DATE: 2-26-19

APPLIES TO: This service bulletin applies to certain 2018, 2019, and 2020 Model Year K2, K3 and K4 model motor home chassis built between October 25, 2017 and February 6, 2019.

CONDITION: The Tire Pressure Monitoring System (TPMS) signal is disrupted for a short period of time.

CORRECTION: TPMS antennas are to be relocated to locations with a more reliable reception rate and update the GIC (Graphical Instrument Cluster, a.k.a digital dash or instrument panel) to display a clearer message when signal is disrupted.

FIG. 3-1

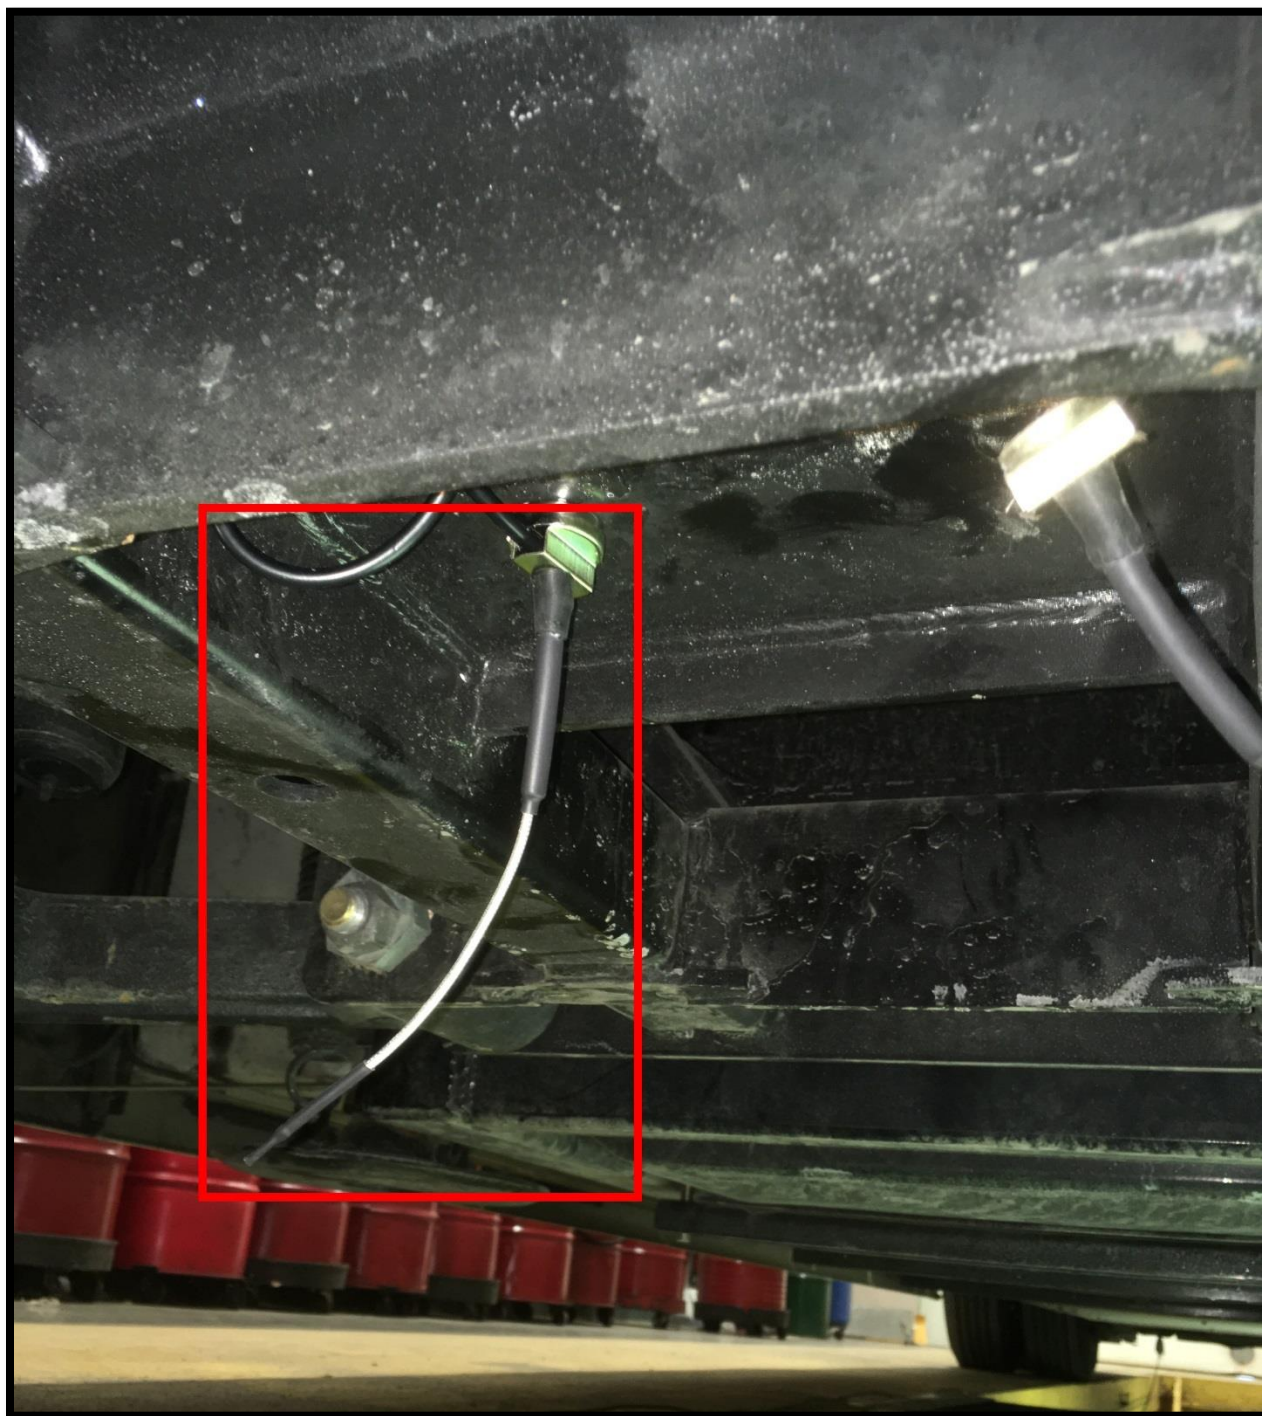
- a. "Ethernet Device Update" screen shown in step 8 on page 9
 - b. Devices tab shown on step 4 on page 12
8. Locate front TPMS antenna on top of IFS cradle; move it to bottom of IFS cradle facing downward. Refer to FIG. 3-1.

FIG. 4-1

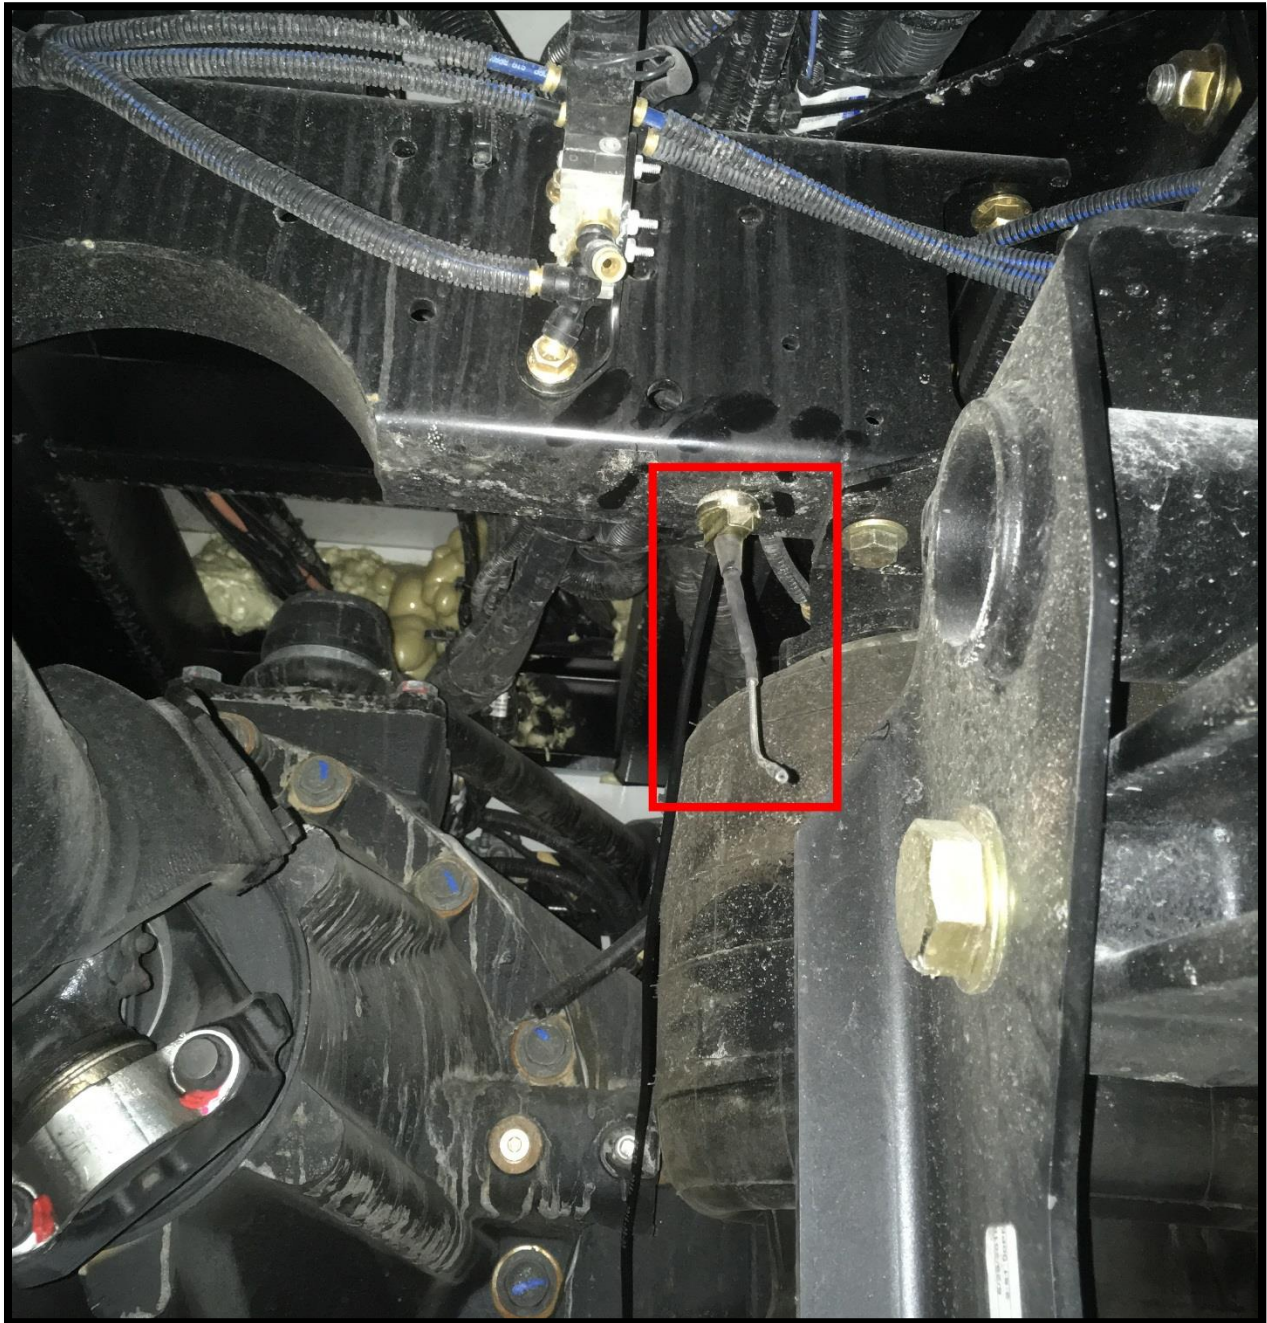
9. Locate TPMS antenna on bottom of rear cross member that holds tag axle integral valve assembly; move it to bottom of crossmember positioned above u-joint, driver side with antenna facing downward. Refer to FIG. 4-1.
